CITY OF ALBUQUERQUE

Re: Marble Brewery
111 Marble Ave NW
Request Permanent C.O. - Accepted
Engineer's Stamp dated: 9-1-15 (J14D140)
Certification dated: 4-11-16

MARBLE BREWERY NEW BUILDING ADDITION

1.	09/1/2015	Rev. Tanks and Update Pond
MARK	DATE	DESCRIPTION
ISSUE:		DRB AA 2014
PROJECT NO:		1407
CAD DWG FILE:		
DRAWN BY:		
CHECKED BY:		
DATE:		8/25/14
SHEET TITLE		
GRADING & DRAINAGE PLAN

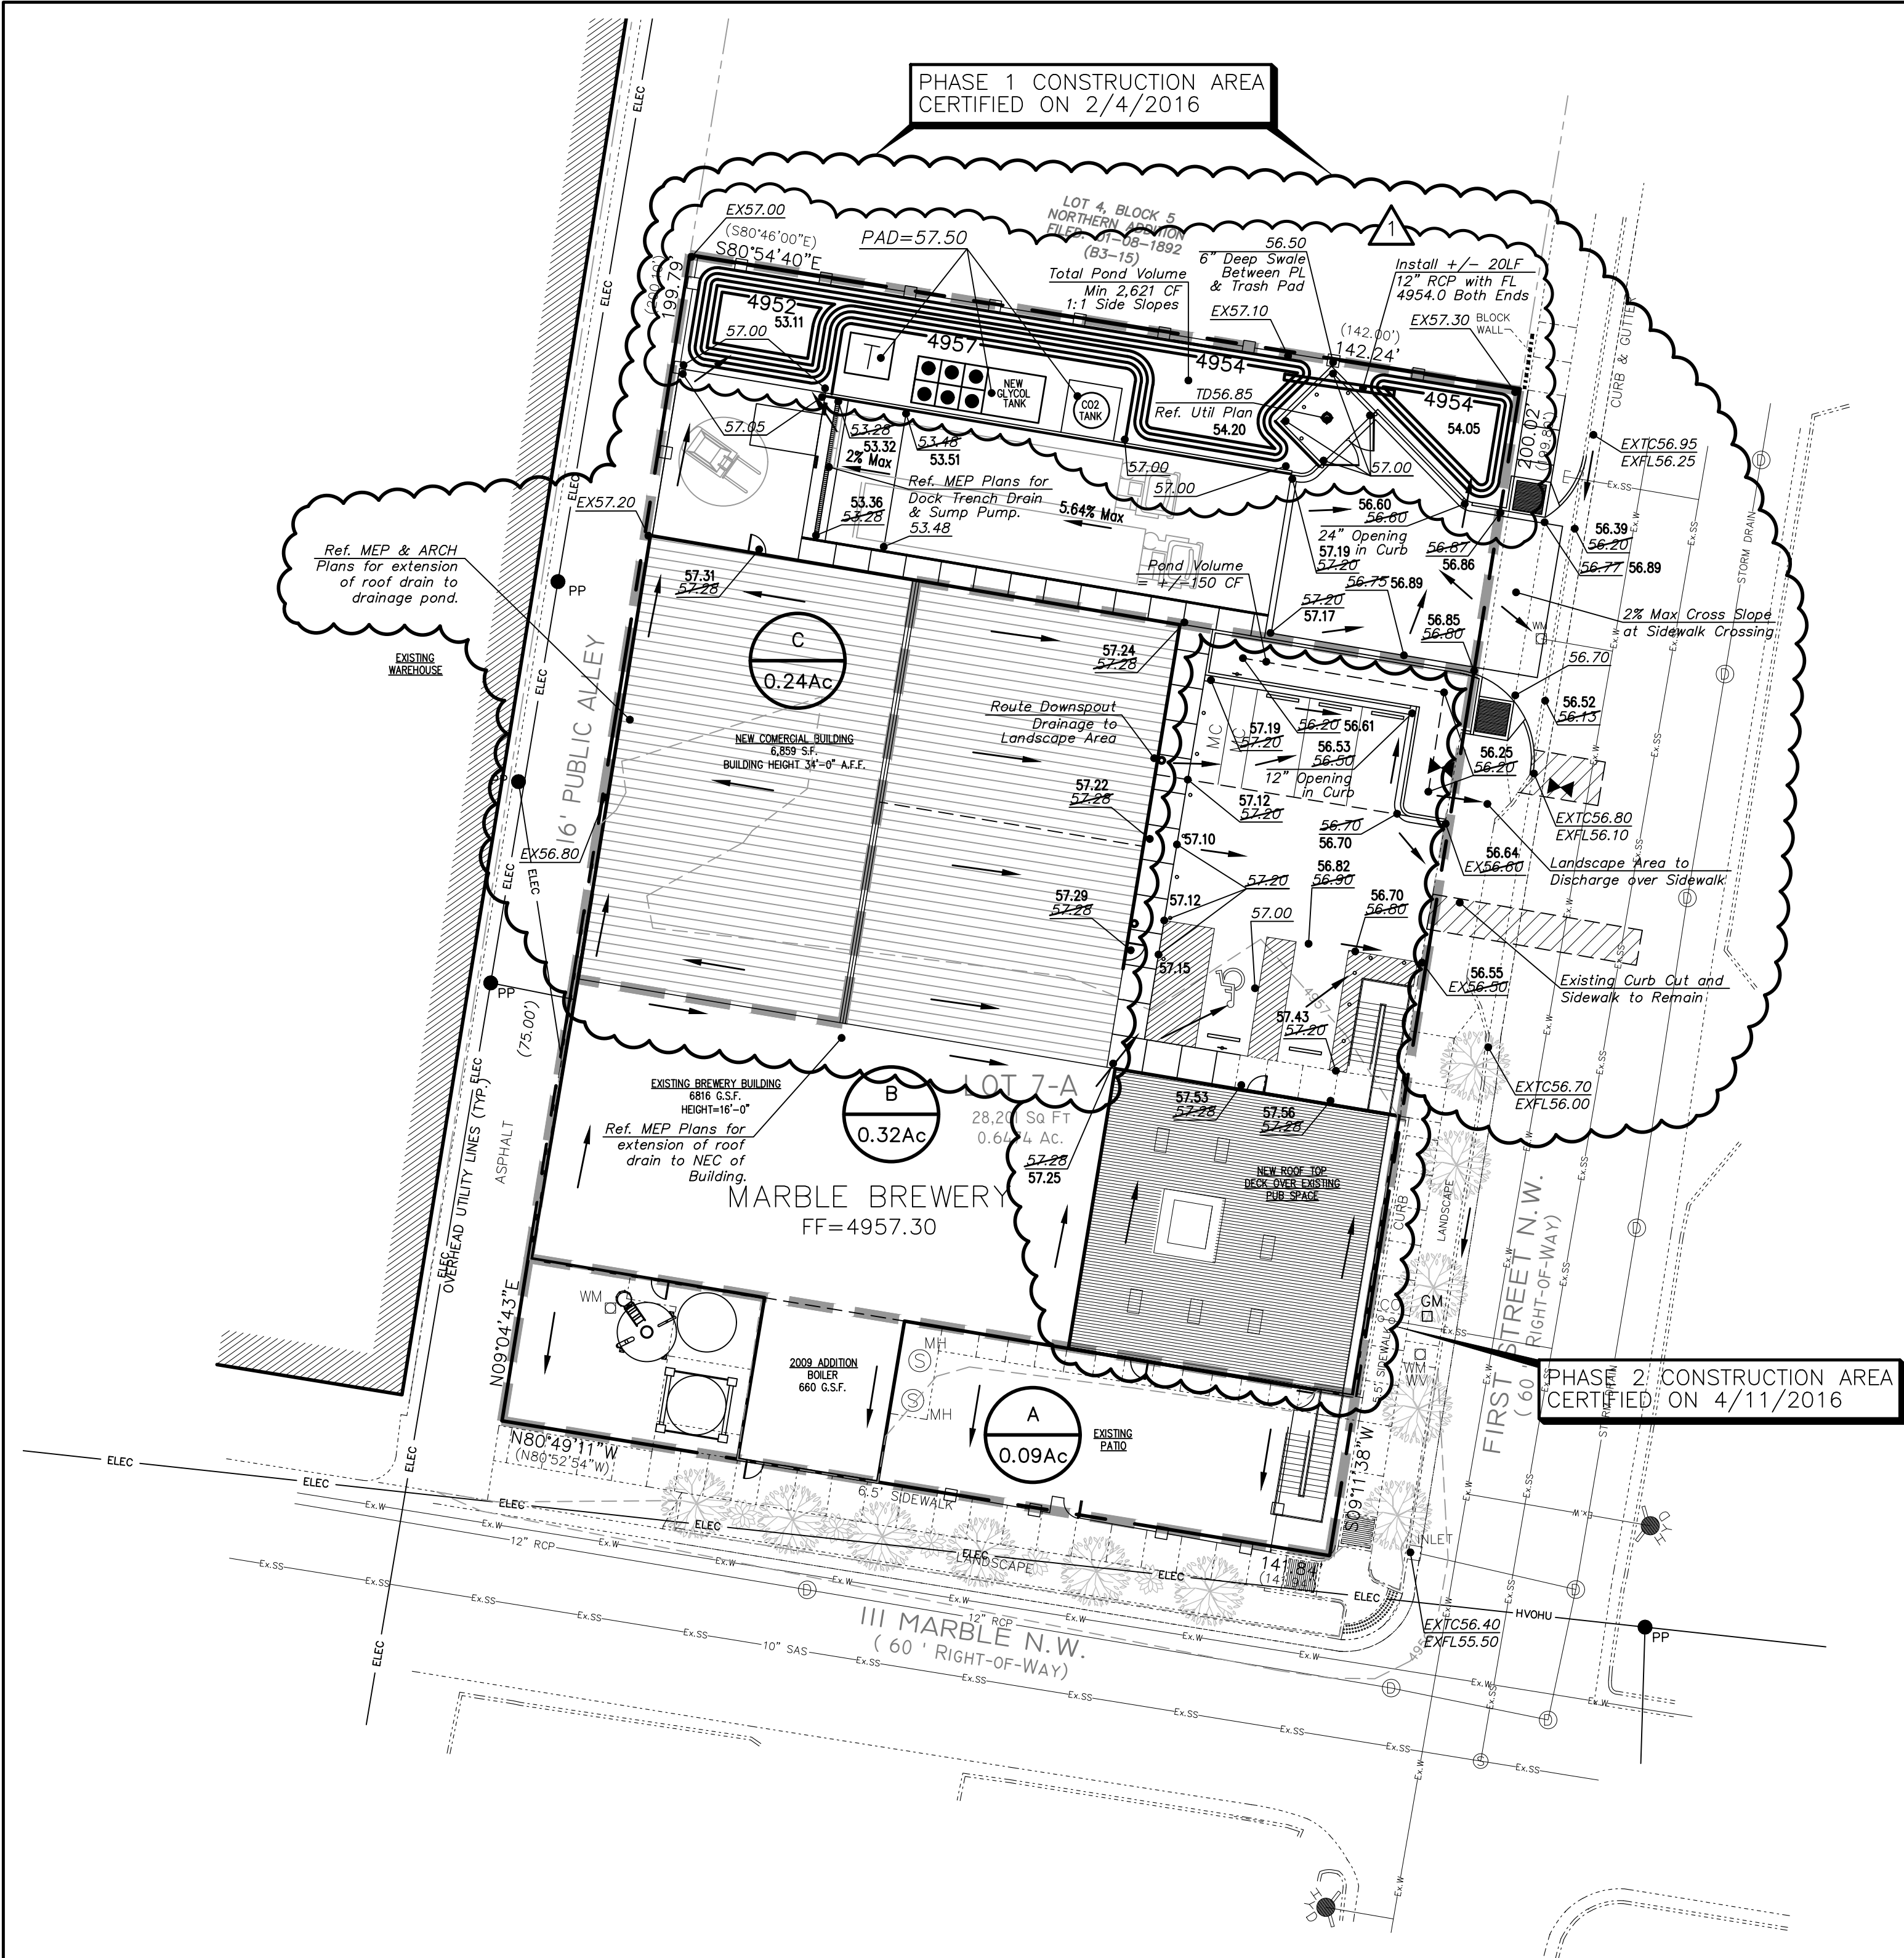
Based on the Certification received 4/12/2016, the site is acceptable for release of Certificate of Occupancy by Hydrology.

I, JEFFREY T. WOOTEEN, NMPE 16892, OF THE FIRM WOOTEEN ENGINEERING, HEREBY CERTIFY THAT BOTH PHASE 1 AND PHASE 2 OF THE PROJECT AS SHOWN ON THE PLAN HAS BEEN GRADED AND WILL DRAIN IN SUBSTANTIAL COMPLIANCE WITH AND IN ACCORDANCE WITH THE DESIGN INTENT OF THE APPROVED PLAN DATED 09/01/15. THE RECORD INFORMATION EDITED ONTO THE ORIGINAL DESIGN DOCUMENT HAS BEEN OBTAINED BY THOMAS D. JOHNSTON, NMPS 14269, OF THE FIRM WAYJOHN SURVEYING, INC. I CERTIFY THAT I PERSONALLY VISITED THE PROJECT SITE ON 4/5/16 AND HAVE DETERMINED BY VISUAL INSPECTION THAT BOTH PHASE 1 AND PHASE 2 IMPROVEMENTS ARE REPRESENTATIVE OF ACTUAL SITE CONDITIONS AND IS TRUE AND CORRECT TO THE BEST OF MY KNOWLEDGE AND BELIEF. THIS CERTIFICATION IS SUBMITTED IN SUPPORT OF A REQUEST FOR FINAL CERTIFICATE OF OCCUPANCY (FINAL C.O.).
